**NOVEMBER 18, 2022**

**CONTRACT NO. 1752**

**REPAIRS TO FLUID BED INCINERATOR NO. 1**

**ADDENDUM NO. 3**

FORCED DRAFT OUTLET EXPANSION JOINT ASSEMBLY

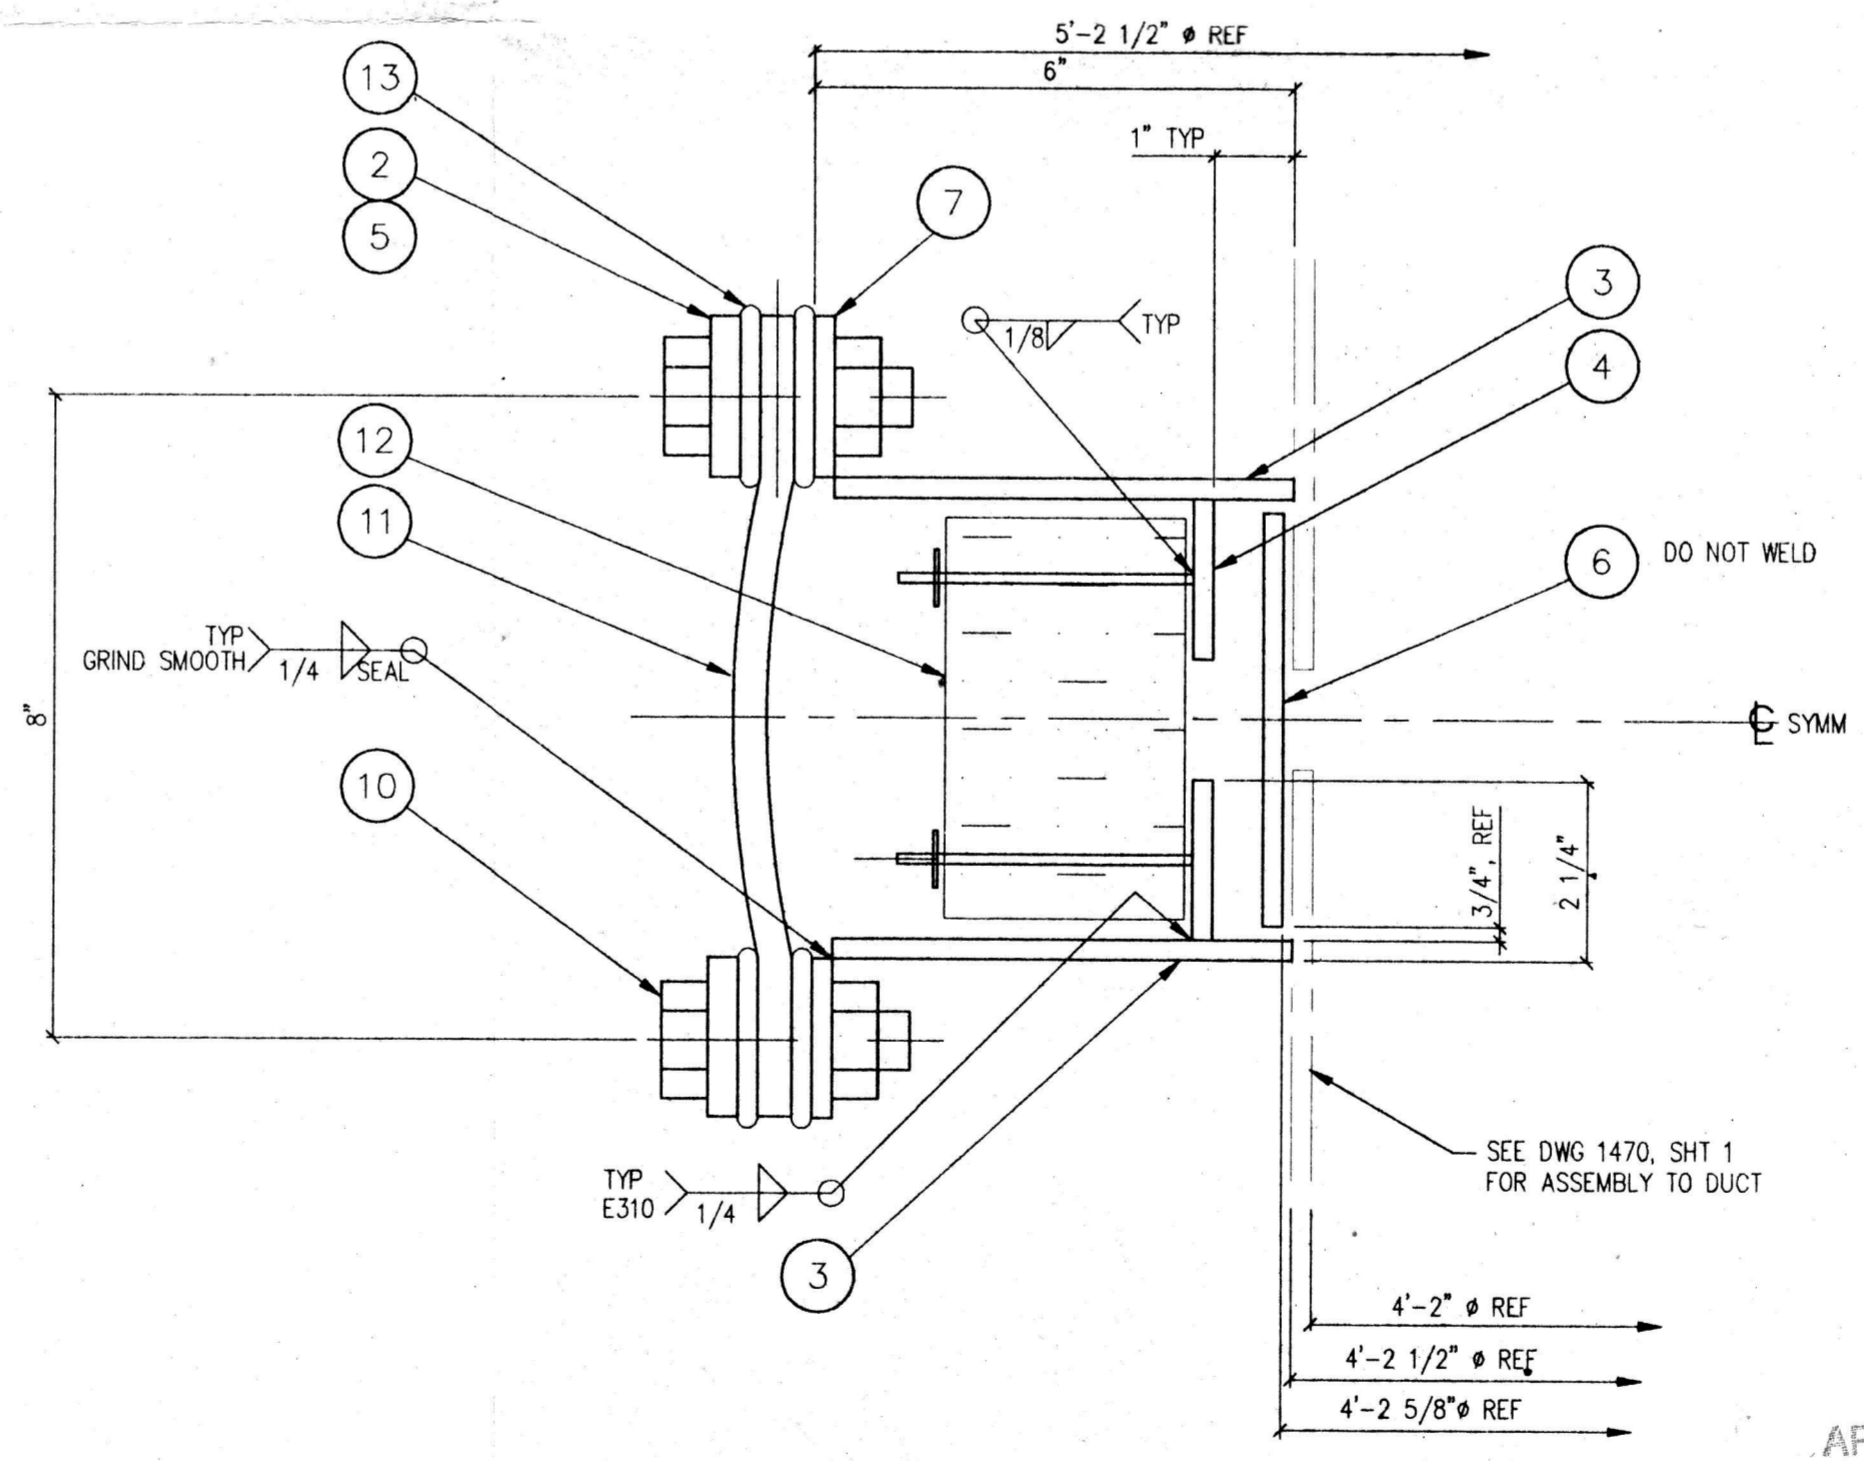
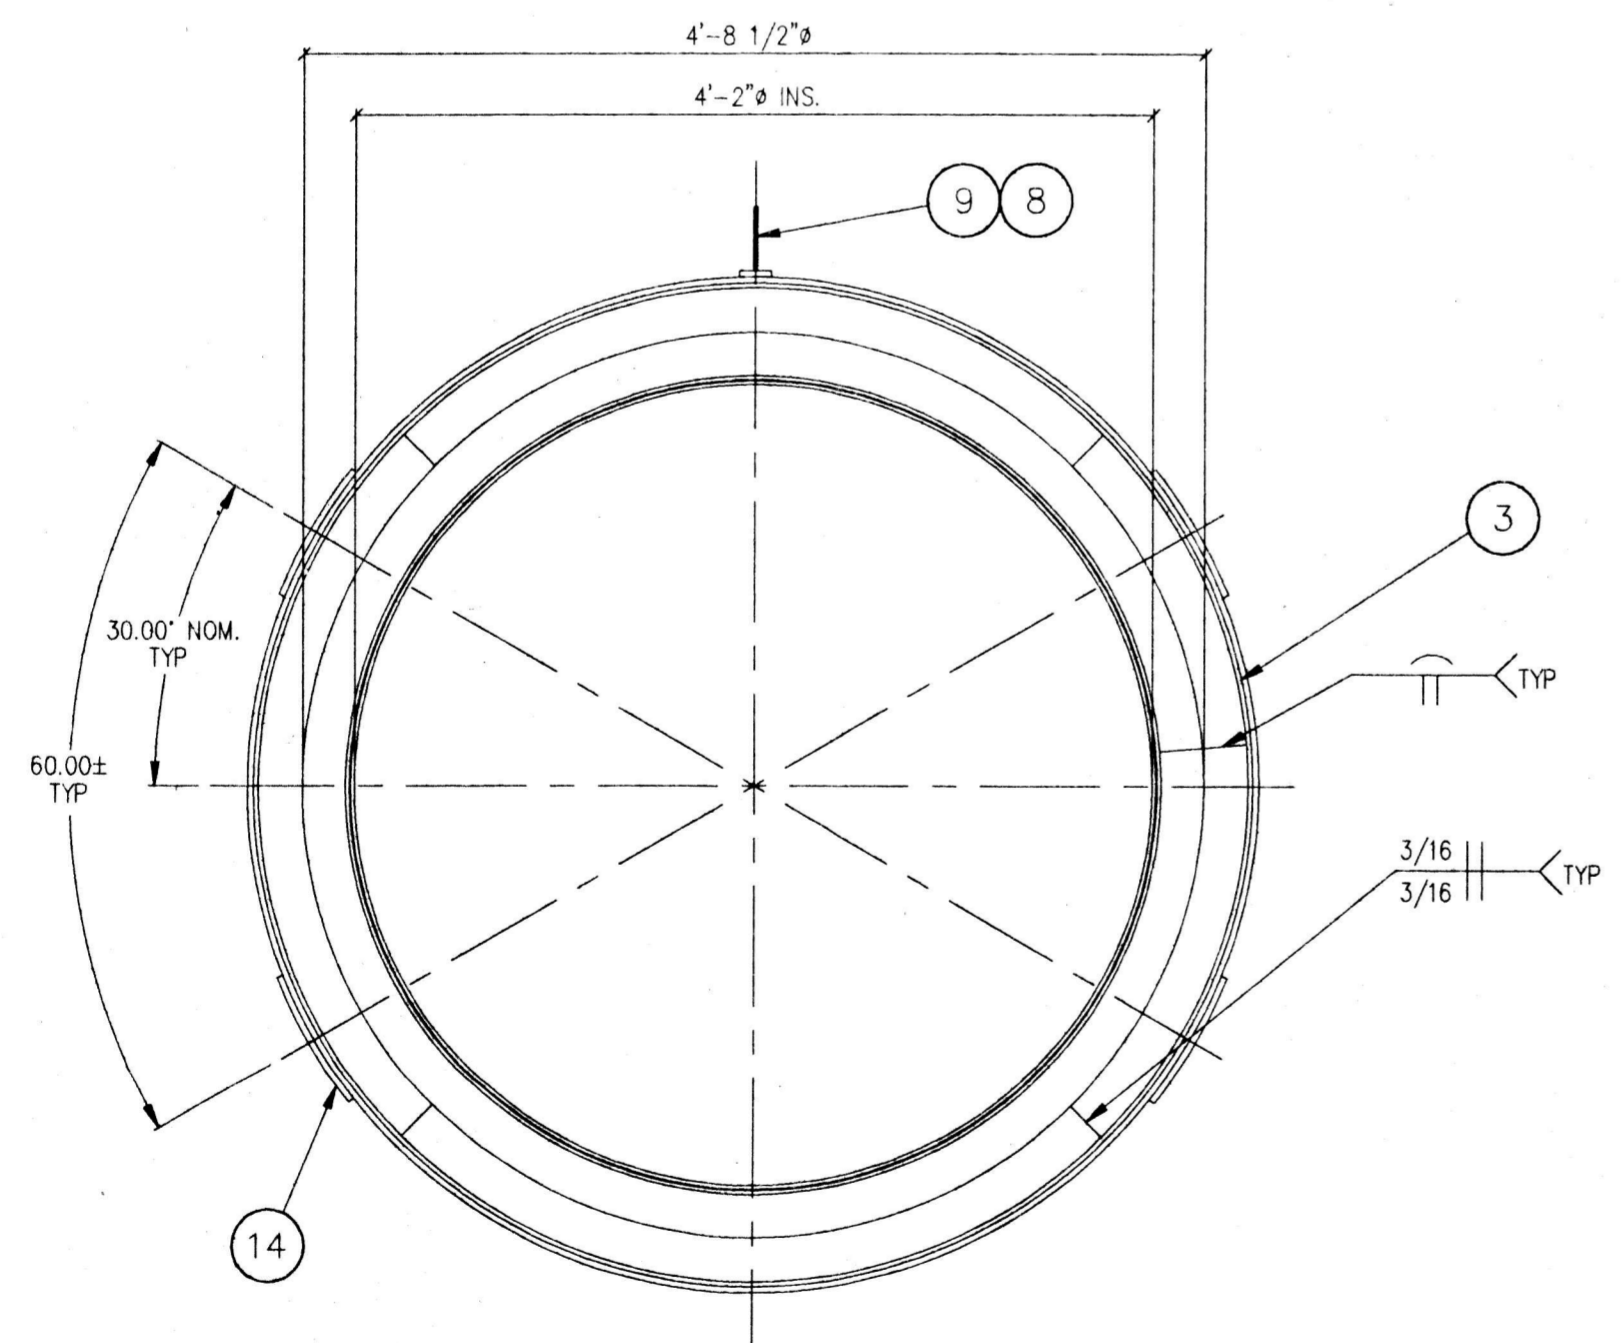
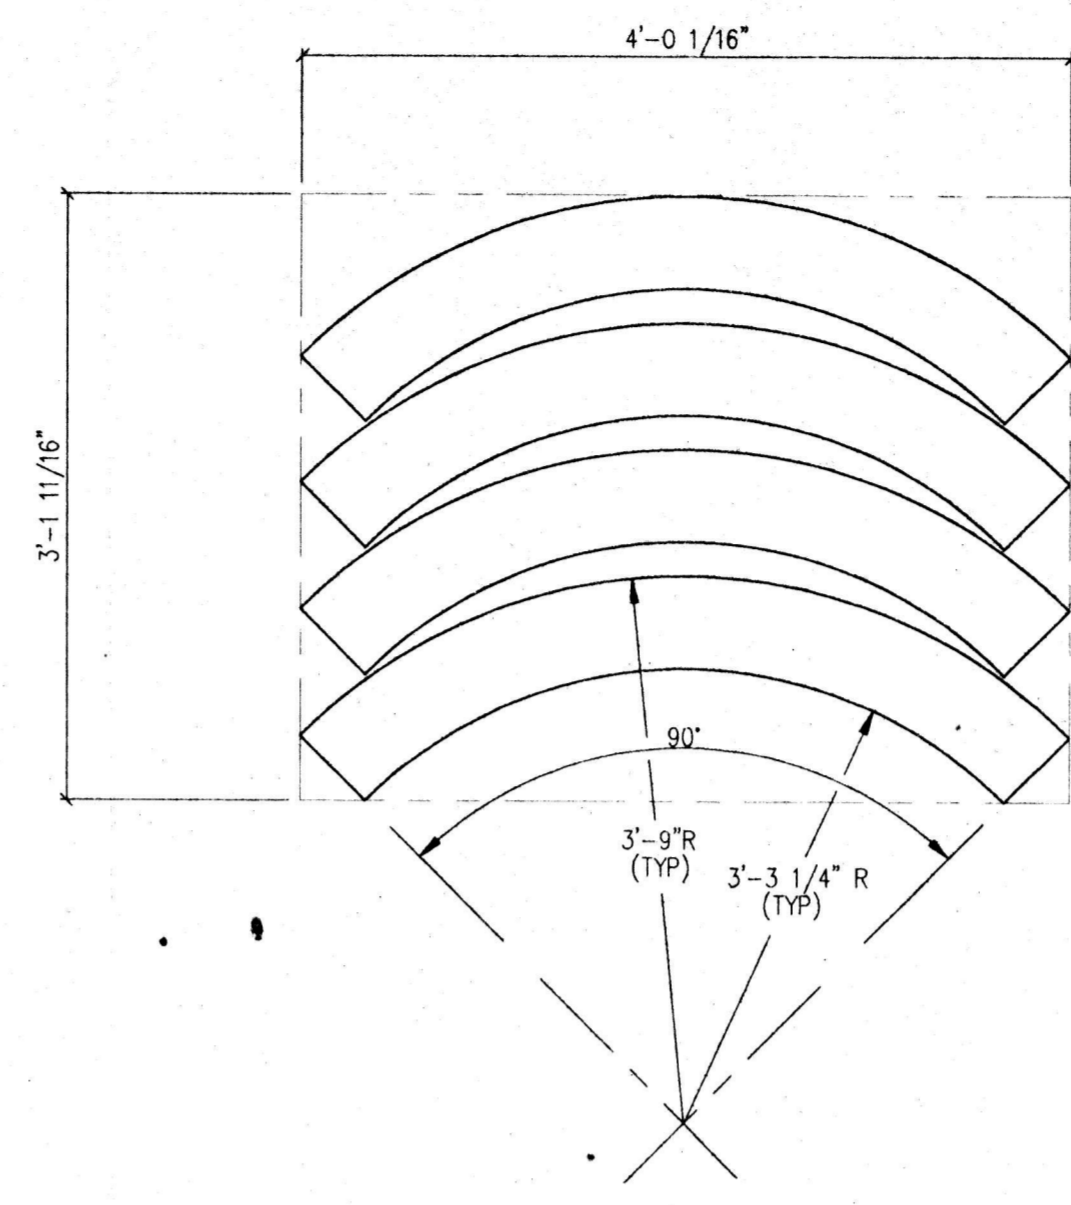
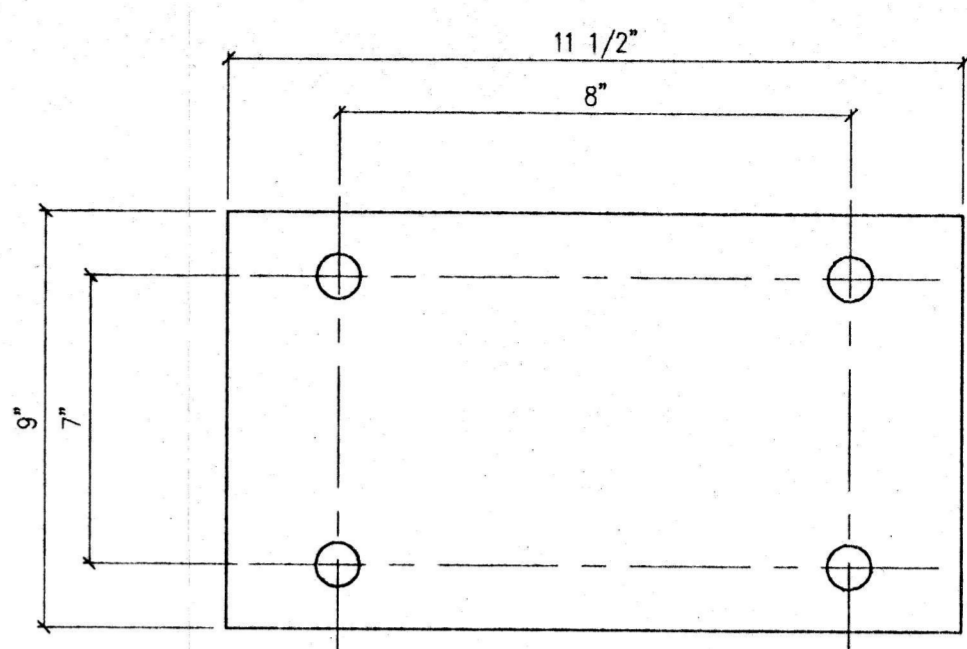
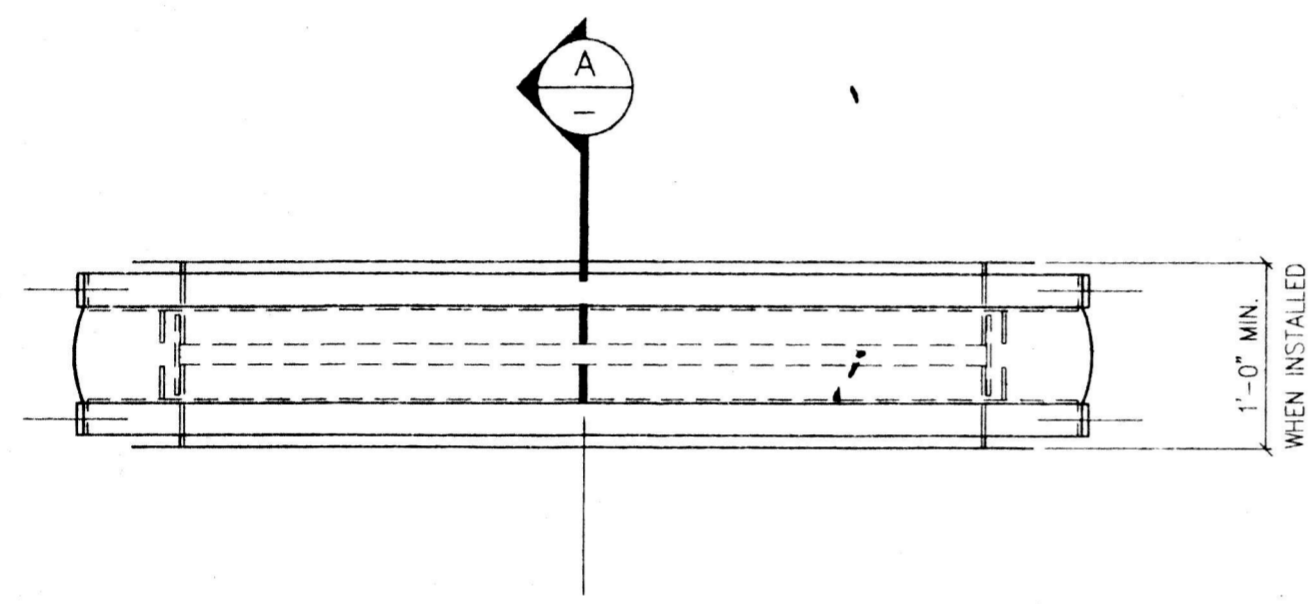
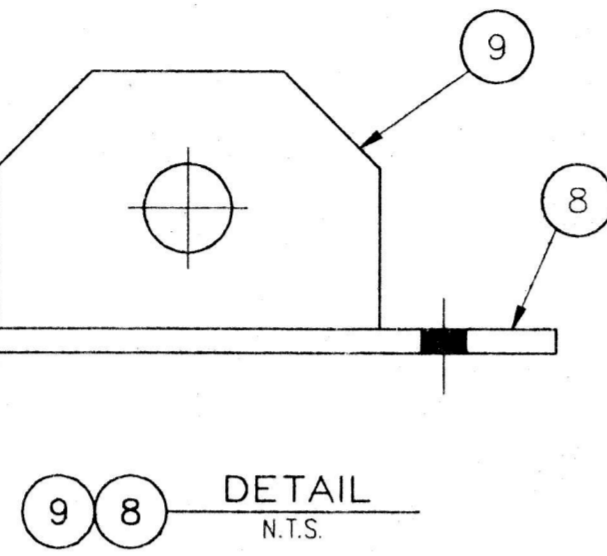
1. Add the following reference drawing to the existing reference drawings:
  - a. **14701-1A** Forced Draft Outlet Expansion Joint Assembly
2. Update the drawing index to reflect the addition listed above.

3. Question: There is still not enough information on the expansion joint. Can any additional information be provided?

Response: We were able to find one additional drawing showing detail of this expansion joint. See the additional reference drawing, attached to this addendum.
